Integrated Isaac Plains Project

This letter responds to the EPA's proposed Environmental Authority (EA) conditions and requests for amendments to the Environmental Management Plan (EM Plan) included in the EIS Assessment Report for the Integrated Isaac Plains Project (IIPP), dated March 2009.

Amended Environmental Authority

Conceptual Final Landform
Cross Section A¹ to A²
Looking Upstream

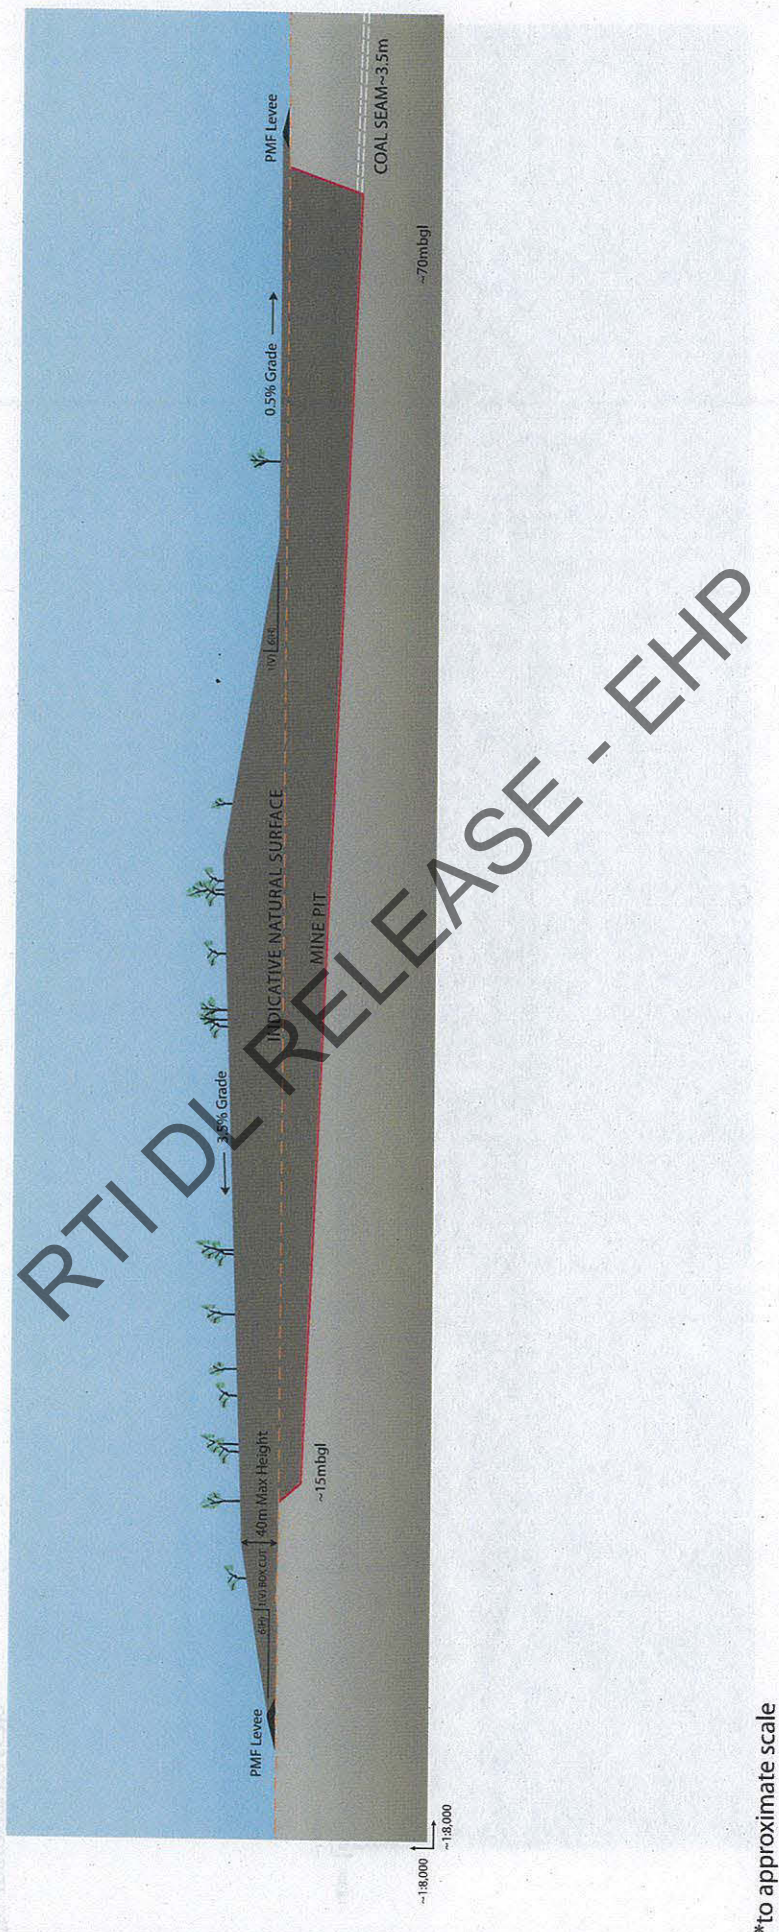
Section 5, EM Plan Section 20.9.3 – The proponent should reconsider the current post-mining landform design and submit in an amended EM Plan an alternative design which addresses the issues raised above.

The amended EM Plan includes updated conceptual final landform plans (Figures 20-16 to 20-21) that include the following changes to address issues raised by the EPA in Section 5 of the EIS Assessment Report:

Figure 6: Pit N1/N2. Lowwall Slopes Greater than Closure Criteria¹⁹

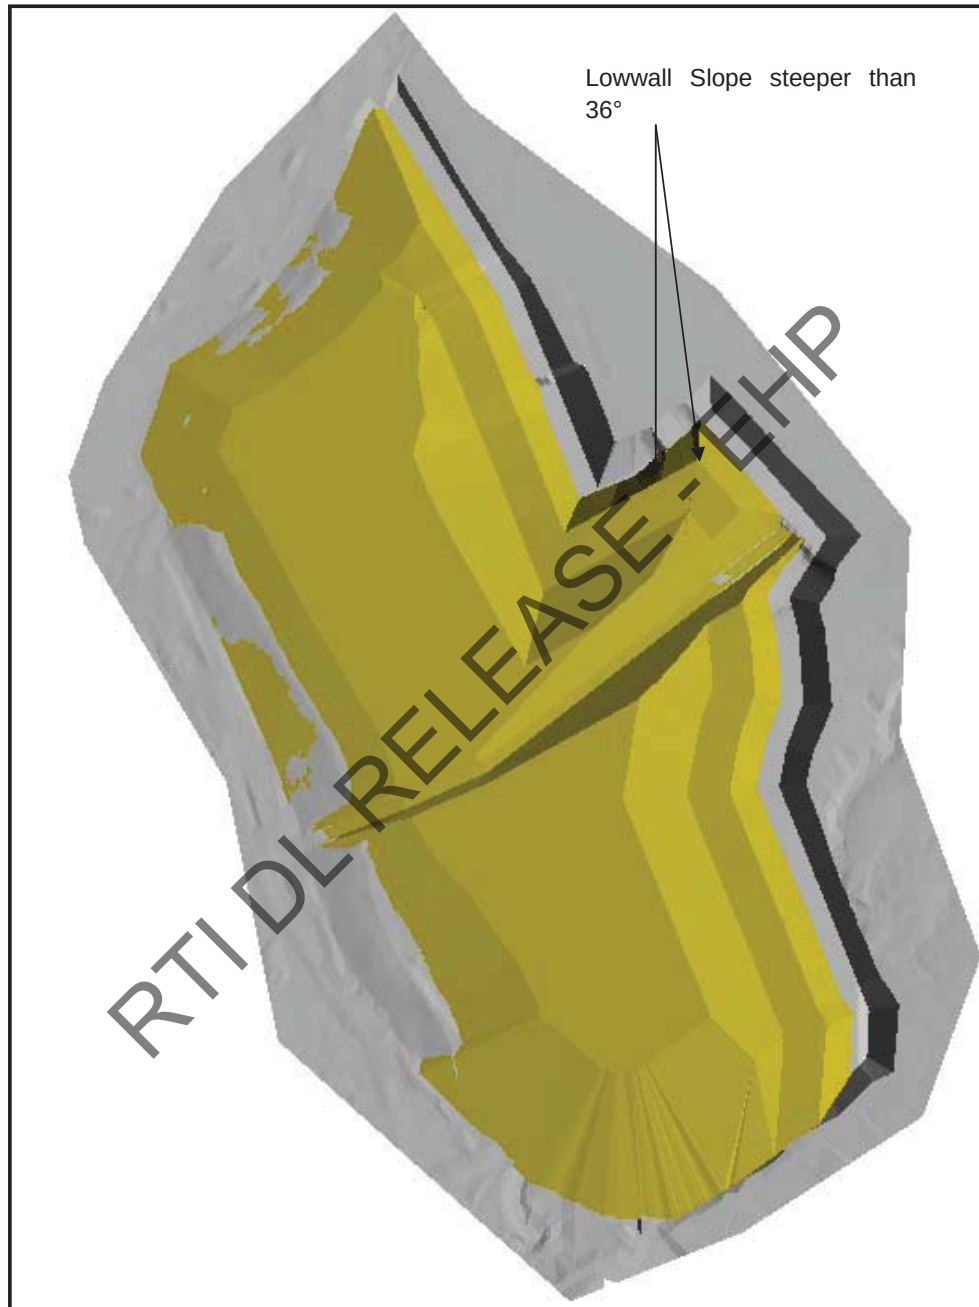
These values relate closely to the Environmental Authority Permit Conditions however in some areas the slope may be 37° as opposed to 36° and adjustment of the design can easily rectify this. There are minor areas along the lowwall in Pit N1 that are steeper than 36° which will require adjustment, (refer to Figure 6 below). Figure 6 also shows a small section of lowwall that can be rectified on the proposed final landform to meet the Environmental Authority Permit Condition F9 for geotechnical stability. External dump faces along the eastern face of Pit S2 where the dump toes onto natural surface require adjustment of the spoil slope to 8.5° from 20° in the south east and 37° in the south. For purpose of geotechnical stability analysis assessment a 36° slope has been assessed as opposed to the 37° which should be adjusted on the proposed final landform design.

Figure 9. Areas of high water flow during significant rainfall events and flooding

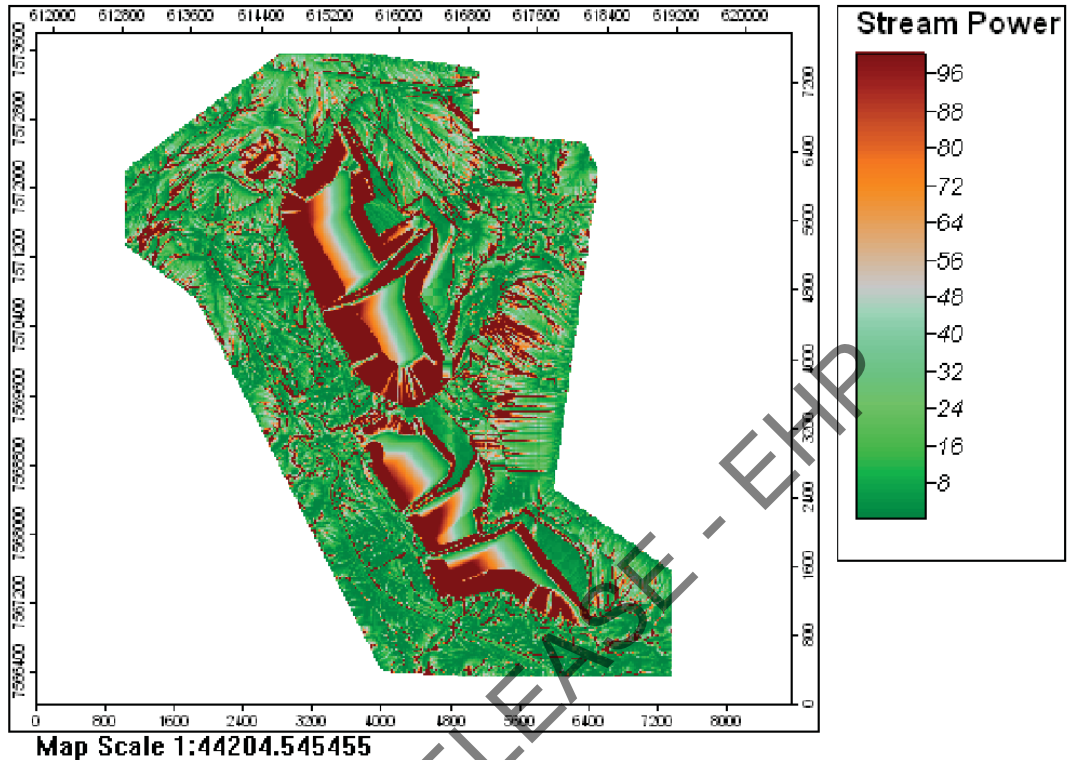
Figure 9 also highlights that the waste rock landform between the northern and southern pits is blocking the natural drainage path, which forces a new drainage path to abut the proposed landform. This should be avoided where possible as it may lead to toe erosion and destabilisation of the external dump walls. It is recommended that in the future landform design revisions, the toe of all external dump walls be buffered by a safe distance to control sediment delivery and undercutting of final batter slopes.

Figure 11: Pit N2 Lowwall Batter Slope.

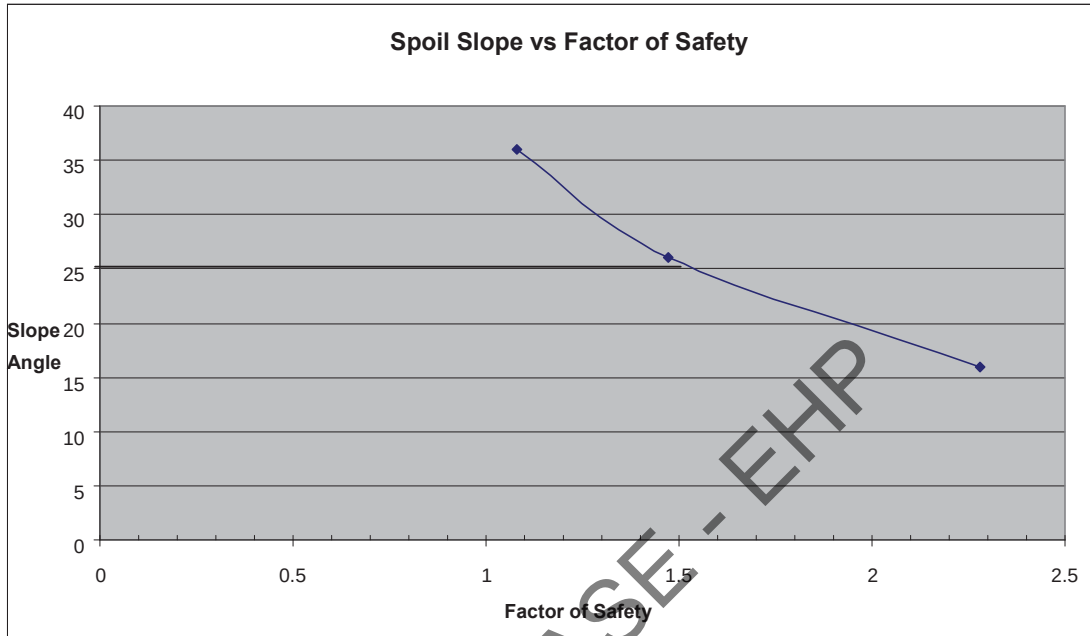
The proposed final lowwall in Pit N1/N2 comprises a 37° dragline spoil slope with a 100m bench and a then 20° truck shovel spoil slope. Assuming a recovered groundwater level of 35m from surface into the final void and saturating the lowwall, the FOS for a 36° slope (Environmental Authority Condition F4) is less than 1.5. Further analysis by reducing the dragline batter slope to 25°-26° and 15°-16° resulted in the attached Figure 11 and Figure 12.

Figure 15: Pit S3 Final Dump and Pit Landform²⁸

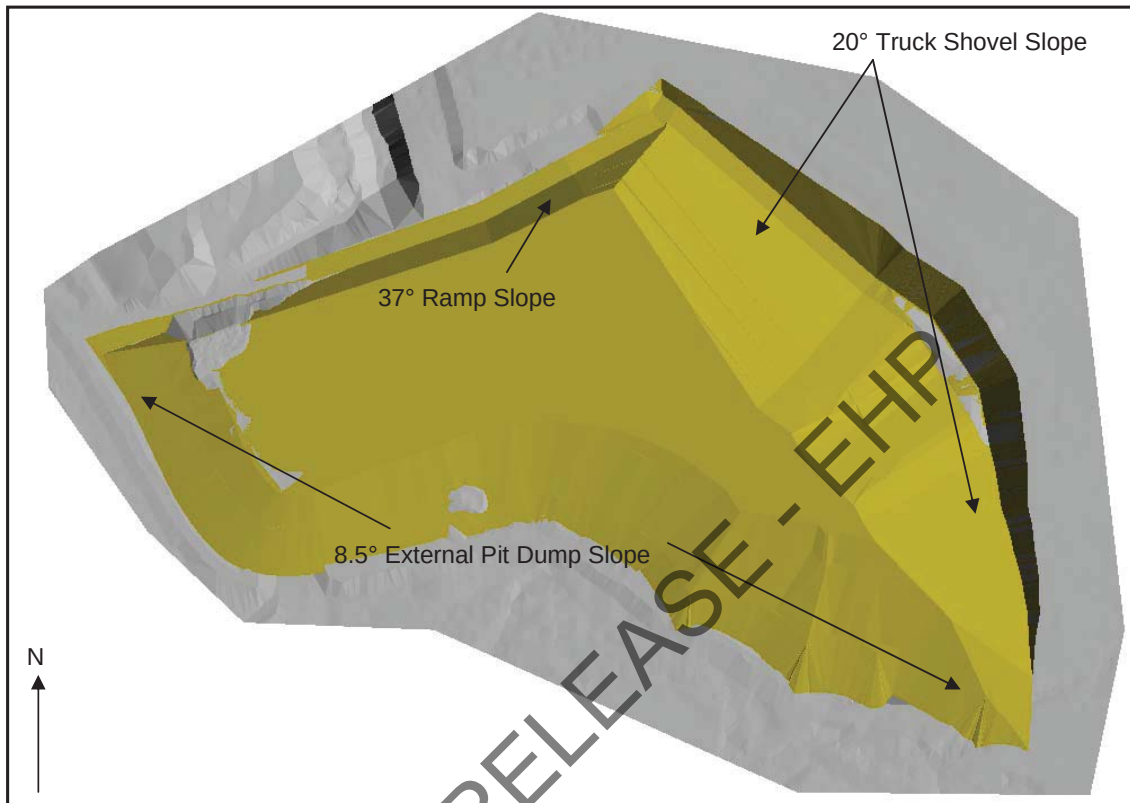
Final landform S3, Figure 15, has a ramp batter angle of 37° which as an incompetent rock slope and residual void should be 36°. The external dump walls are 8.5°, highwalls 45° and lowwalls that toe out into the pit are 20° in this truck and shovel excavated pit.
